**PUR-1378**  
**ADDENDUM NO. 3**  
**INVITATION TO BID**

**THE MARYLAND THEATRE EXPANSION  
IN HAGERSTOWN, MARYLAND**

**DATE: Thursday, March 29, 2018**

**A7** ENLARGED PLAN OF CUSTOM CHANDELIER  
1" = 1'-0"

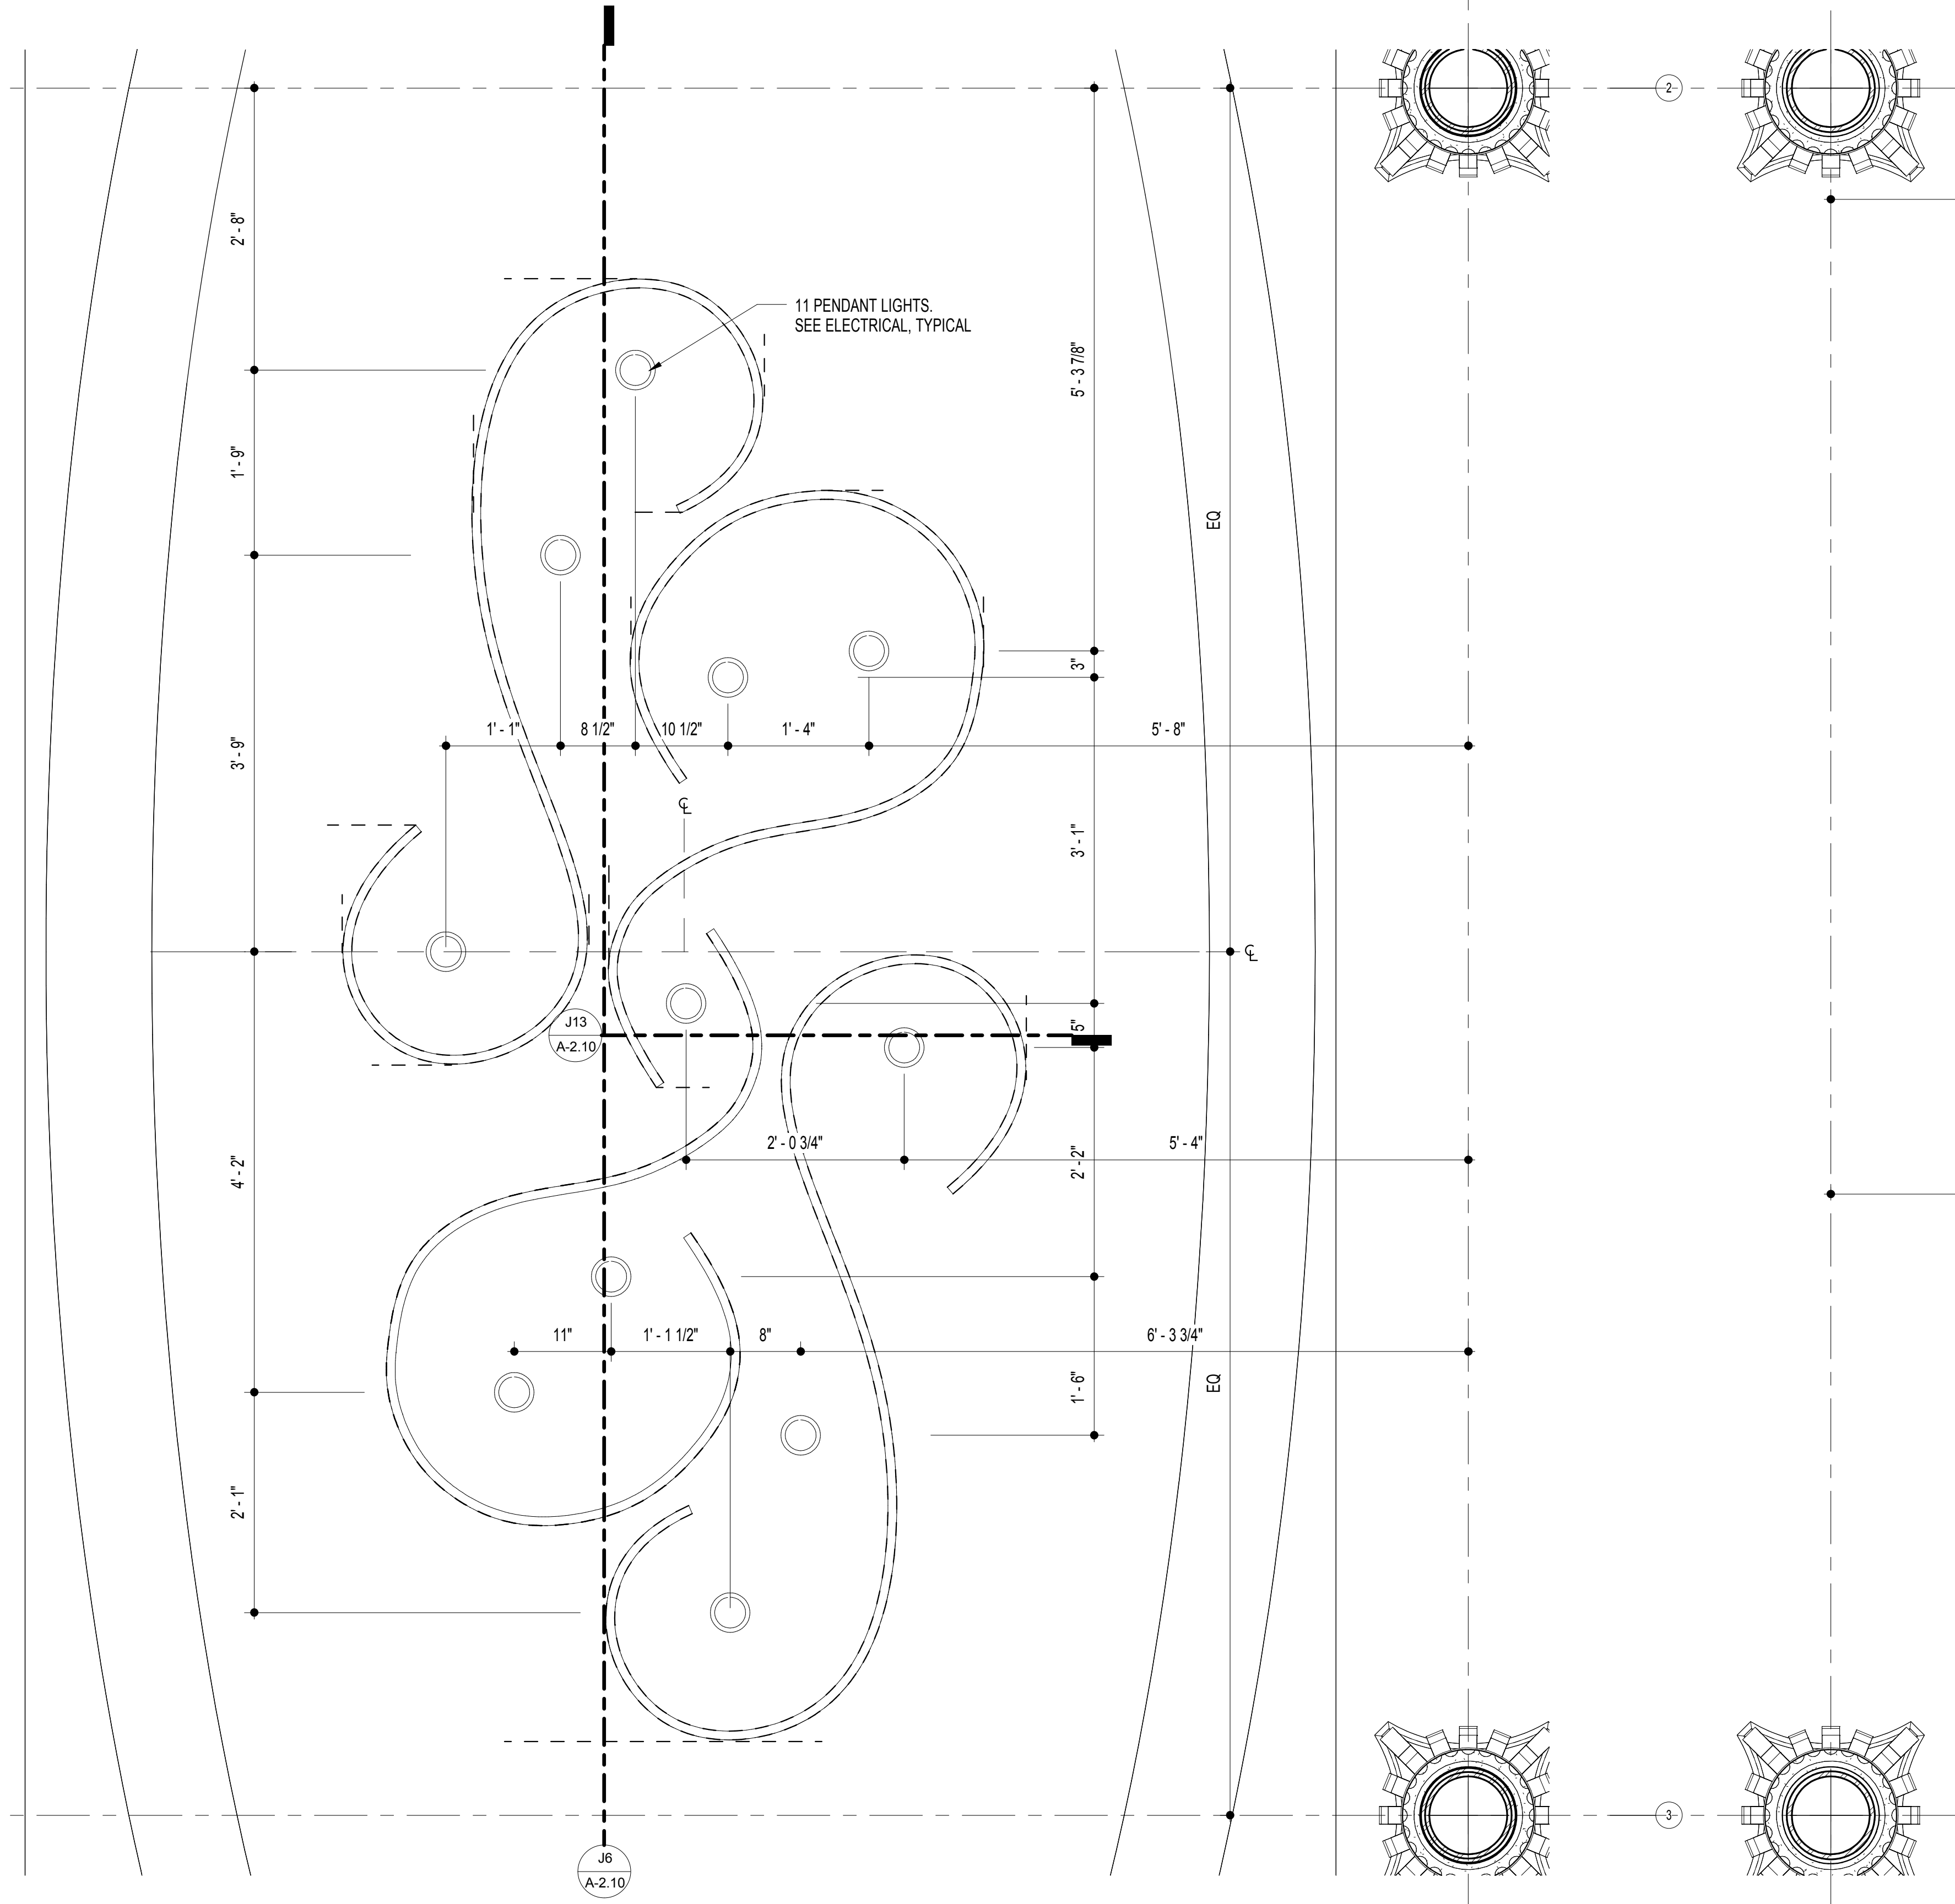
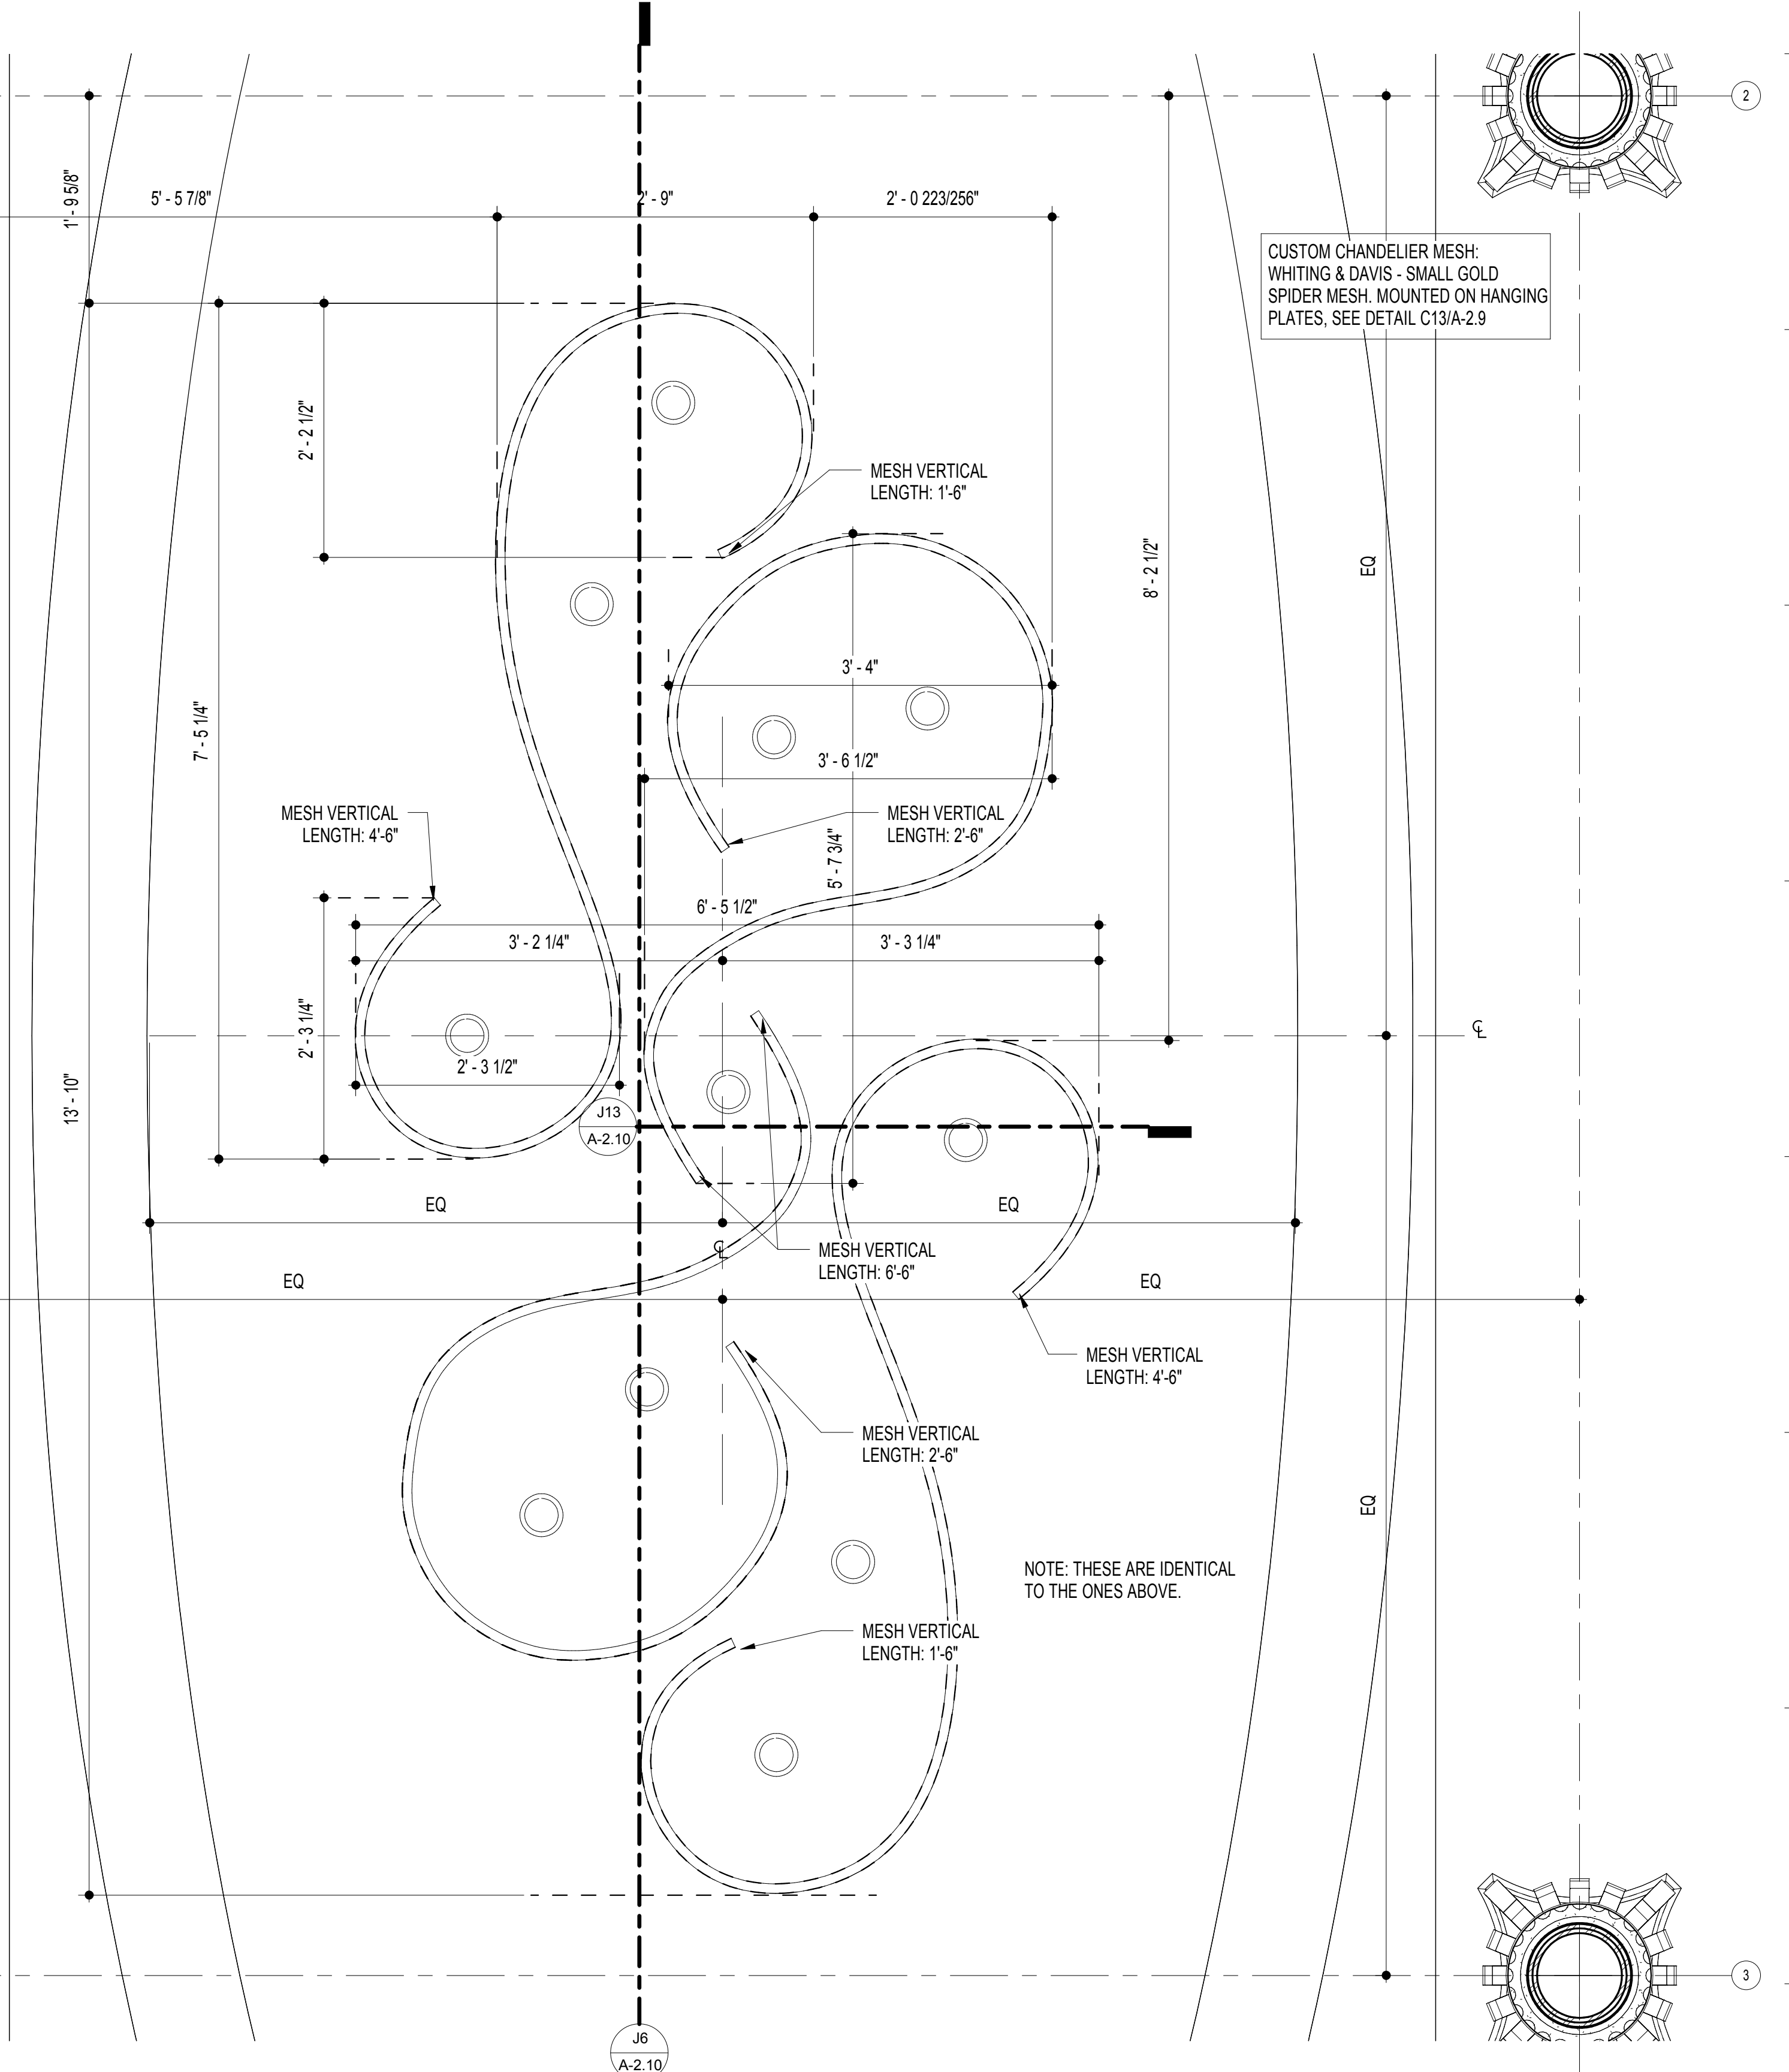
**ITEM NO. 16:** *Inquiry:* On pg. A-2.3 there is a "Custom Decorative Mesh Chandelier w/ Pendant Lights". Is the custom decorative mesh to be provided by the GC or the Owner? If provided by the GC, please provide a manufacturer & model # of the chandelier that is to be used.

**ITEM NO. 56:**     SHEET A-2.10 – CUSTOM DECORATIVE CHANDELIER DETAILS  
**(SHEET ATTACHED)**

**ADD**             New sheet of Plans and detail of the custom Decorative Chandelier.

*Response:* The Custom Decorative Mesh Chandelier to be provided by the GC. The chandelier is a mix of globe pendant lights, see Electrical light Type N. Mesh material is from Whiting & Davis – Small Spider Mesh in Gold. Mounted on Hanging Plate. See ITEM NO. 56 (in this Addendum) and new sheet A-2.10 for all details.

CUSTOM CHANDELIER MESH:  
WHITING & DAVIS - SMALL GOLD  
SPIDER MESH. MOUNTED ON HANGING  
PLATES. SEE DETAIL C13/A-2.9

**THIRD FLOOR PLAN - MECHANICAL**  
1/8" = 1'-0"

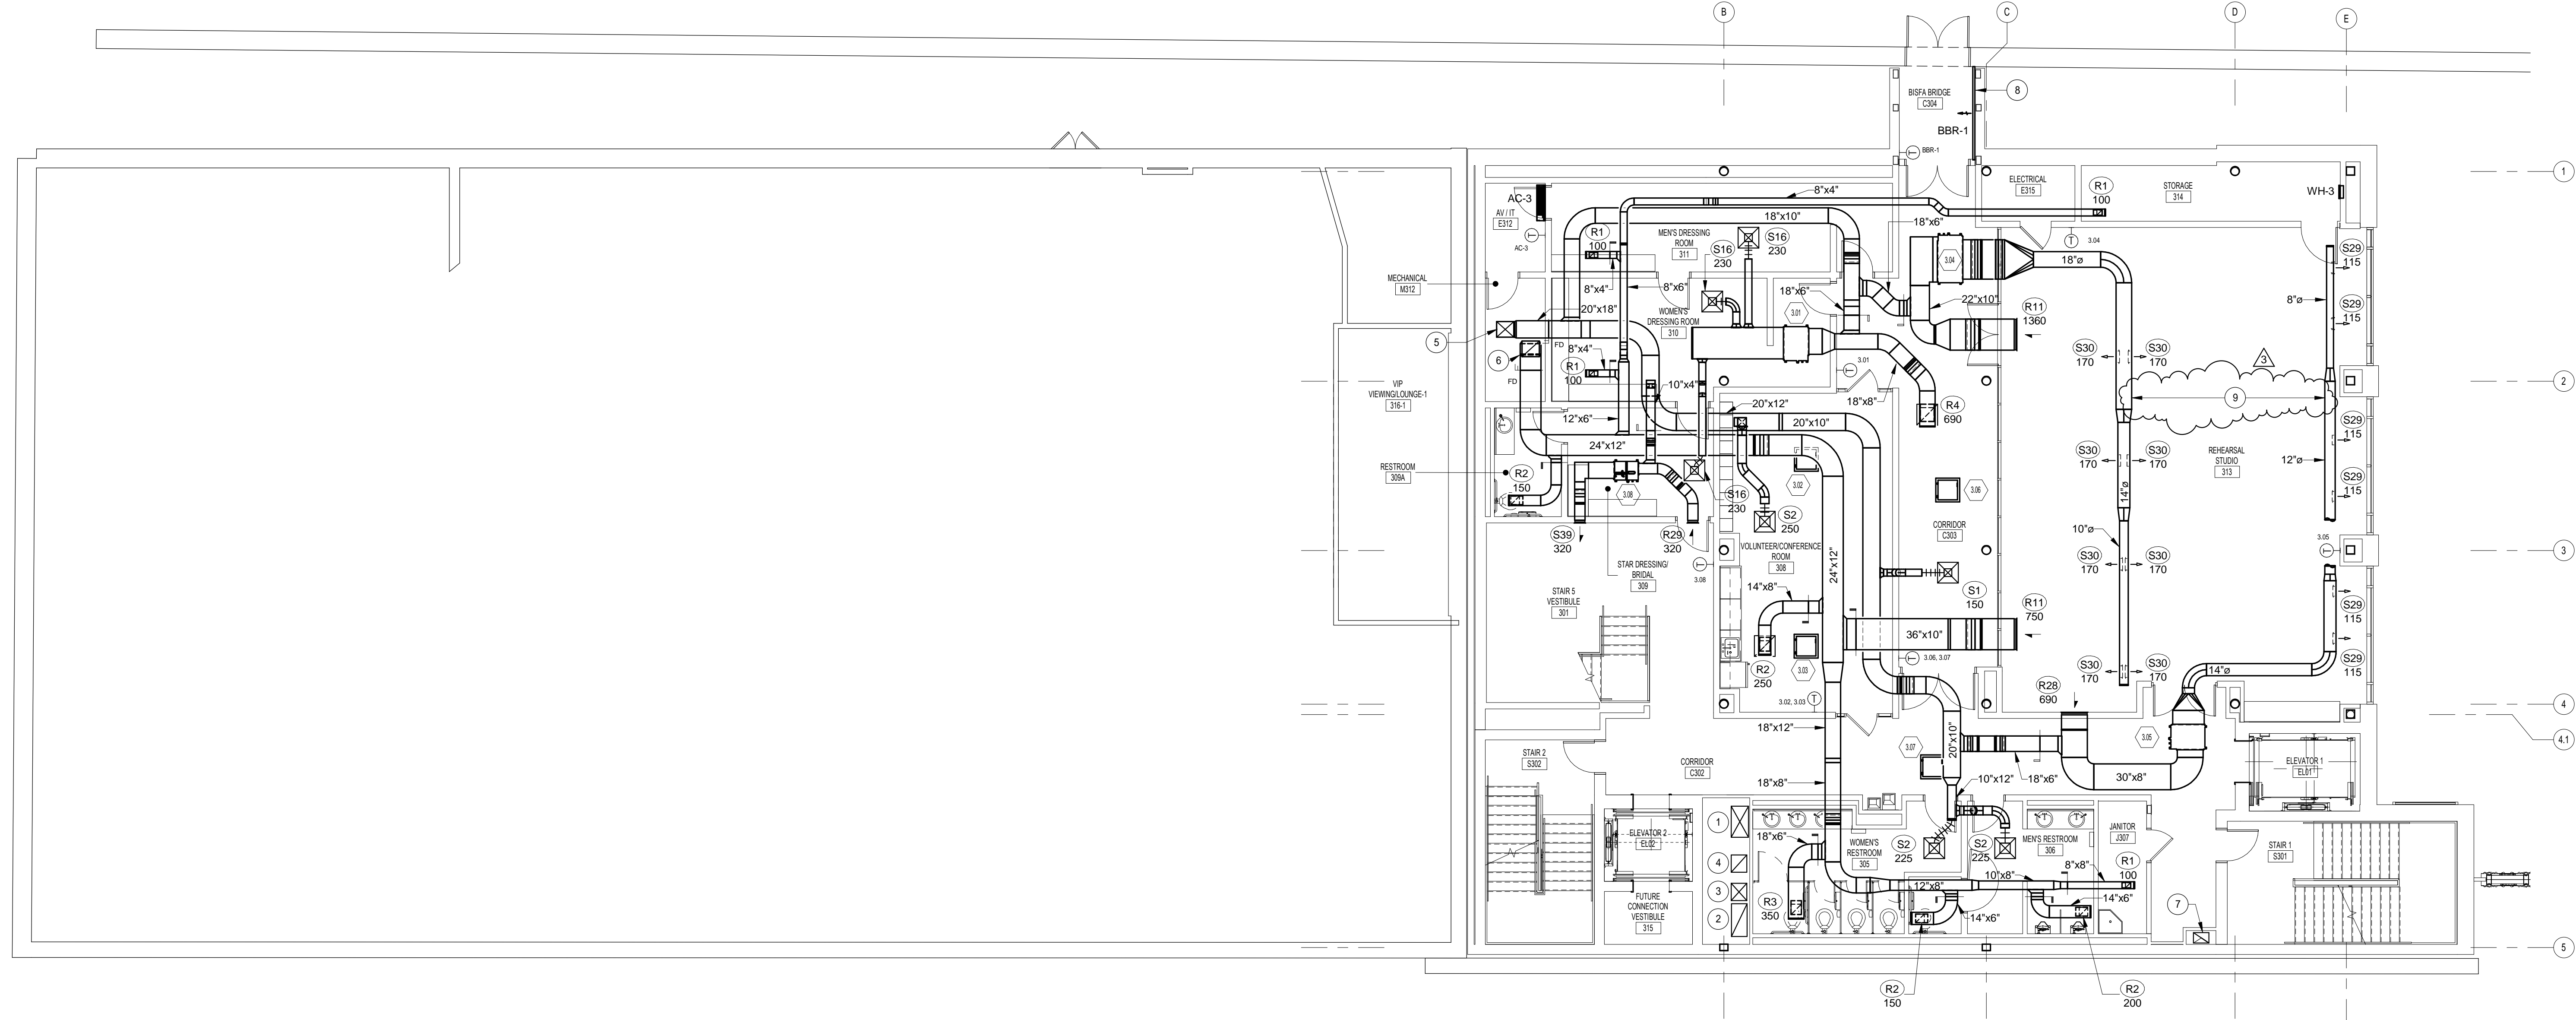
**ITEM NO. 58:**     SHEET M-2.4 – THIRD FLOOR PLAN - MECHANICAL  
**(SHEET ATTACHED)**

**ADD**             Drawing note #9. Locate drawing note in rehearsal studio 313.

**REVISE**          Drawing note #3.

**REVISE**          Drawing note #4.
